# TECHNICAL INFORMATION

57608

- Subject** ▶ Change in Switch and Noise suppressor
- For Models** ▶ 9047S, 9049S, 9057S, 9059S, 9027S, 9029S, 9037S, 9039S
- Country** ▶ See "Note" of "Interchangeability (I/C)".
- Description** ▶ The current switches cannot be supplied by our supplier ( production discontinued).

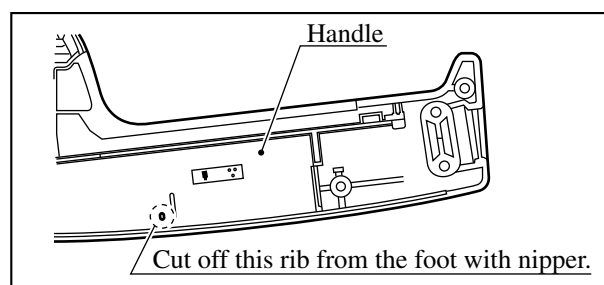
▶ Current	▶ New
Switch	 <p>Change in delay mechanism</p> <p>Change in Noise Suppressor receiving part</p>	
Noise Suppressor (Changed to smaller one to suit to the modified Noise suppressor receiving part of Switch)

The combination of New switch and Current noise suppressor might result in the interference of a rib inside Handle.  
So, remove the Rib before installation.
